RE: Charles River Basin Pedestrian and Bicycle Connectivity Study

I thank you for the opportunity to comment on the Charles River Basin Connectivity study.

Figure 9 -- Crossing between path and street is incorrectly located for bicyclists.
From Figure 54 of the report.

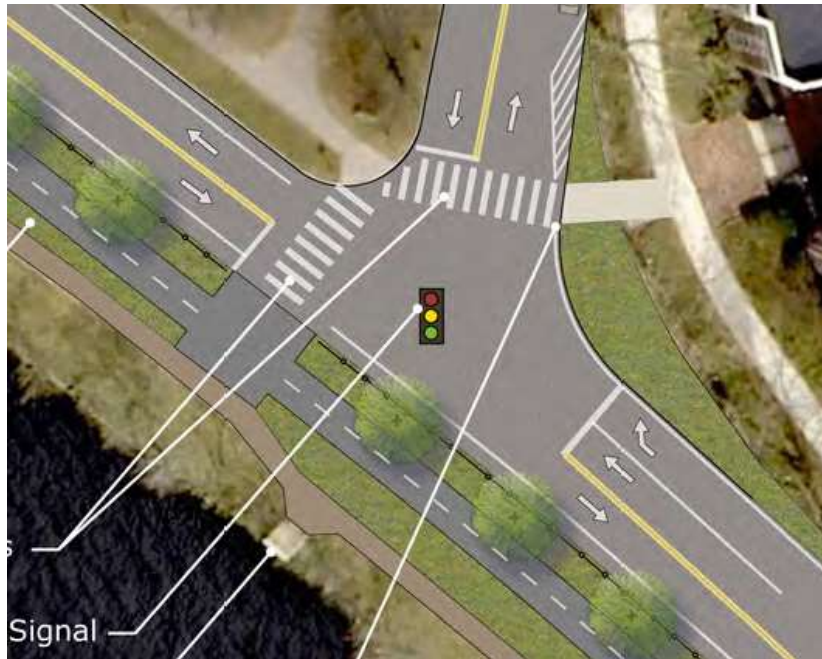
Figure 54 shows faulty connections between Hawthorn Street and the path south of Memorial Drive. Bicyclists turning from the path to Hawthorne Street need a connection which leads them to continue legally on the right side, not the left side, of Hawthorn Street. Bicyclists headed from Hawthorn Street to the path also need a connection farther downstream so that they are not hazardedously placed to the right of traffic turning right from Hawthorne Street to Memorial Drive.

Figure 11 – BU Bridge rotary. This won't work. Hazardous when traffic is light, completely blocked in evening rush hour Figure 60 from the report.

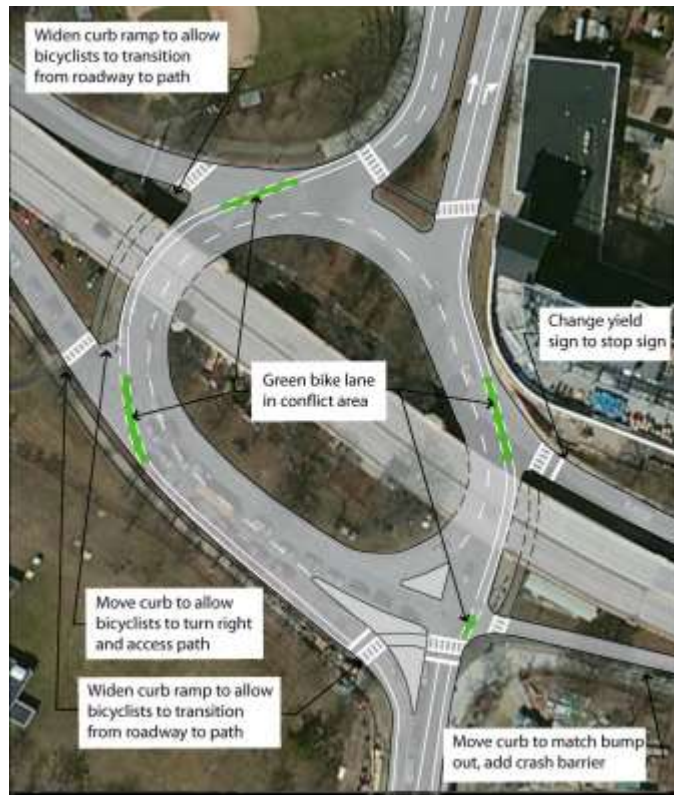
The design shown in Figure 60 is hazardous and deprecated. It places bicyclists in blindspots of motorists who enter and exit this antiquated rotary without having to slow. The 1992 German study *Sicherung von Radfahrern an Städtischen Kreuzungen* (Safeguarding bicyclists at Urban Intersections) established this, see graphic at

<http://bernd.sluka.de/folien/gif/Kreisverkehr1.gif>. The three bars in the graph are, from left to right, for no special bikeways, for bike lanes (like those proposed for the BU Bridge rotary) and for bikeways close to the outside of the rotary. For safety's sake, the rotary must be reconfigured as a roundabout, with deflection to slow entering and exiting traffic, and bicyclists must either merge into the flow of motor traffic before entering the intersection (driver behavior), and/or cross in crosswalks well outside the intersection, where motorists yield (a Dutch approach, see video at <http://www.youtube.com/watch?v=wEXD0guLQY0>)

However, *none* of these approaches works with the congestion in the evening rush hour at the BU Bridge. In a car, the few hundred feet from Waverly Street in Cambridge and through the BU Bridge rotary to the bridge can take 15 minutes. Bike lanes and crosswalks are useless when cars are backed up across them and unable to move. Much of this congestion results from traffic backed up on Memorial Drive all the way from the Western Avenue Bridge. The only effective solution, as I mentioned in the previous section, is traffic reduction.

Figure 12 -- Claire Saltonstall bikeway. Section at left through the BU campus has gone into disrepair.

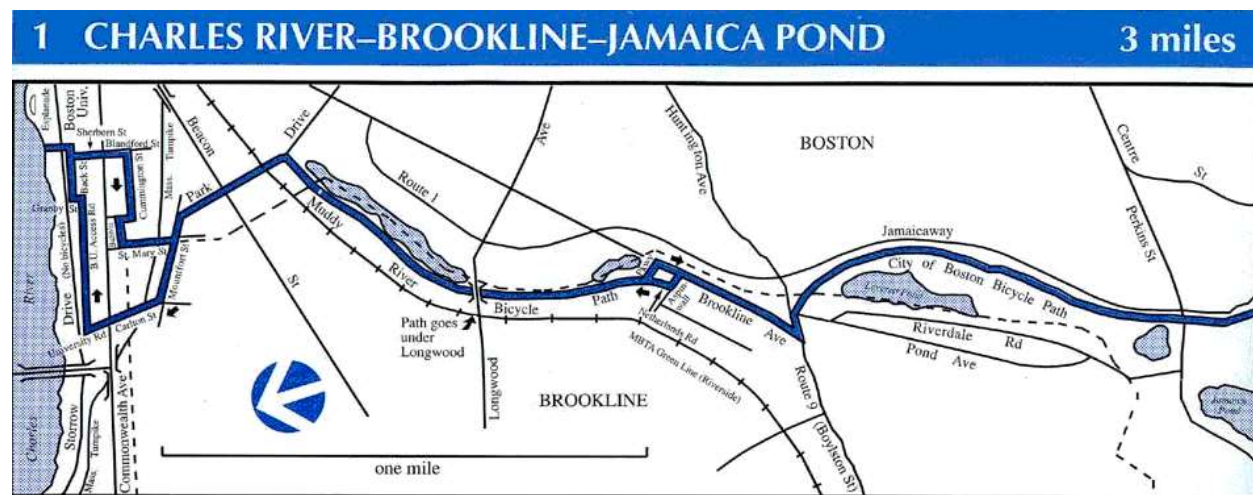
This overpass, in addition to Sherborn Street, Cummington Mall, Babbitt Street and St. Mary's Street, were designated as links in the Claire Saltonstall Bikeway, see <http://www.crw.org/claire.htm>. This segment has gone into disrepair. It should be restored and improved. A contraflow lane on St. Mary's Street would avoid the need for an opposite-direction route on busy Carleton Street and University Road. I discuss this at more length in my article "Connecting the BU Campus," cited in the previous section.

Figure 14 -- Charles Circle, figure 72 from the report.

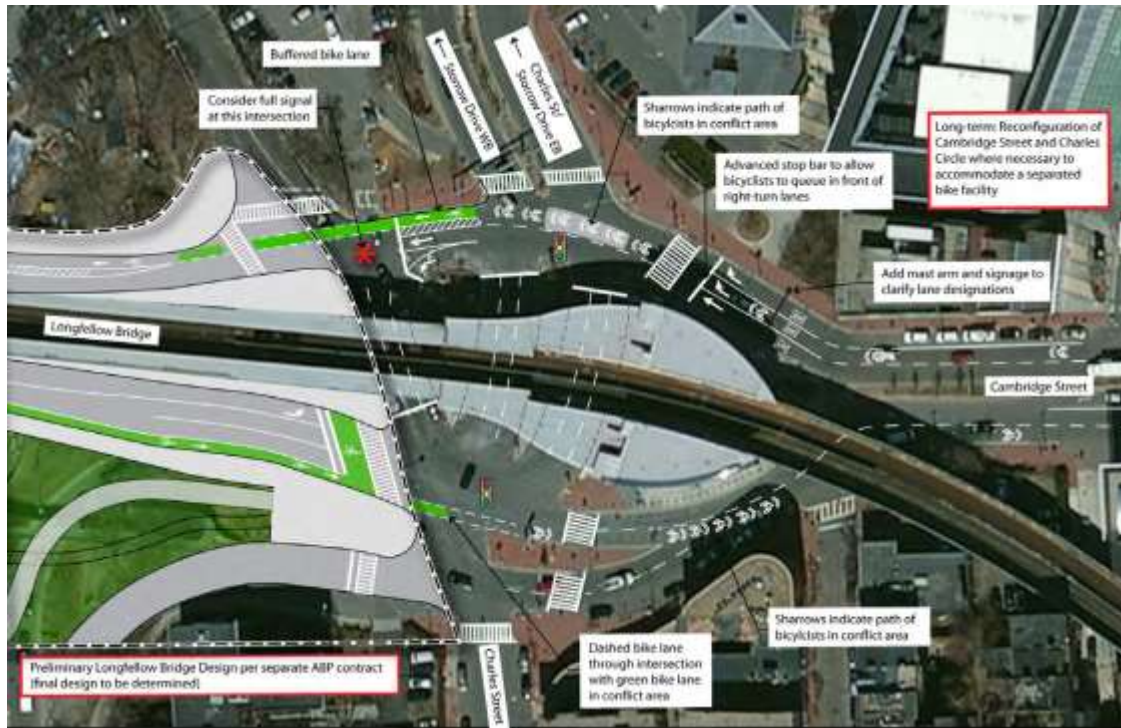
Are bicyclists really to be expected to make a 135-degree hairpin turn, and ride illegally toward waiting motor traffic, to establish their lane position in a bike box as they come down off the bridge? I see that this is a preliminary design, but it is so bizarre that I am astonished to see it published anywhere.

Dill and Monsere's research in Portland, Oregon confirms observations I made at the much more conventional existing bike box on Commonwealth Avenue at Charlesgate East, where bicyclists are only expected to turn 90 degrees and cross in front of waiting traffic: bicyclists do not enter bike boxes on the red light. Waiting in bike boxes happens on the red light: they are irrelevant on the green light. My report on the observations is at <http://john-s-allen.com/blog/?p=5750> and links to a video.

I repeat a comment I have made in the past: that bicyclists approaching Charles Circle from the Longfellow Bridge have two safe options: either to merge into the travel lane, or to bear right onto the pedestrian plaza and enter Charles Circle on the same signal phase with pedestrian traffic. Both of these routes avoid conflicts with the traffic turning right onto Charles Street. (See comments at the bottom of page 1 of <http://john-s-allen.com/plandocs/longfellow.doc>.)

The report suggests a separated bikeway. To afford real separation from the complicated motor traffic in Charles Circle, such a bikeway would have to be grade-separated. Anything less will only add some mix of complication, delay and conflicts.

Figure 15 -- Leverett Circle, figure 77 from the report.

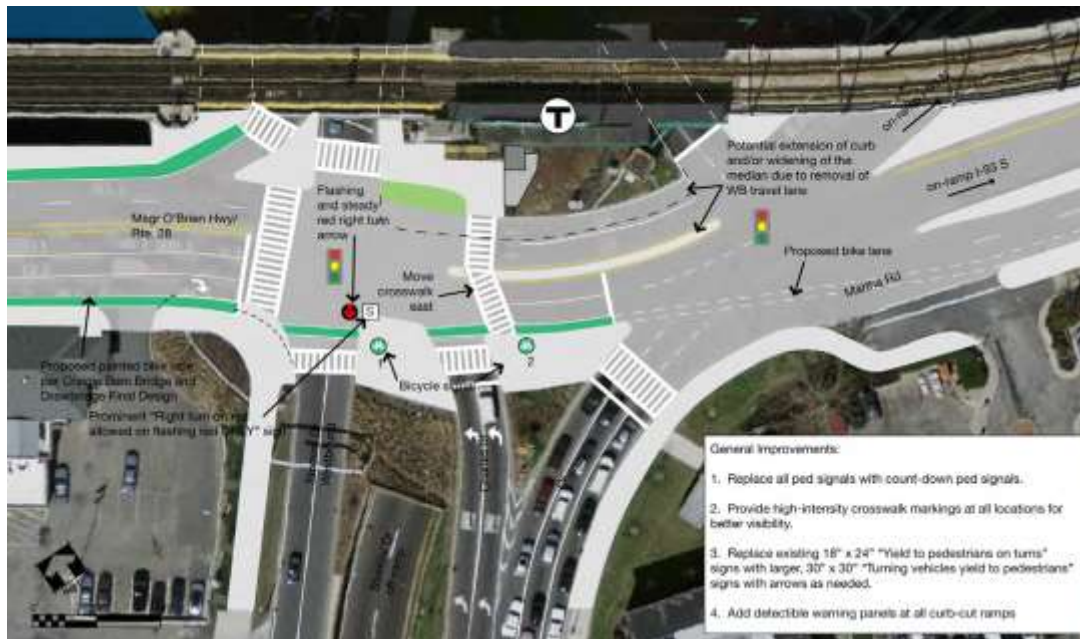
Figure 77 shows a bike lane to the right of a right-turn lane. With or without a flashing red, this is in violation of AASHTO guidelines and invites right-hook collisions, which can be fatal. Bicyclists must have full signal protection if they are entering the intersection from the sidewalk, and should be encouraged to ride in line with other traffic if on the roadway.
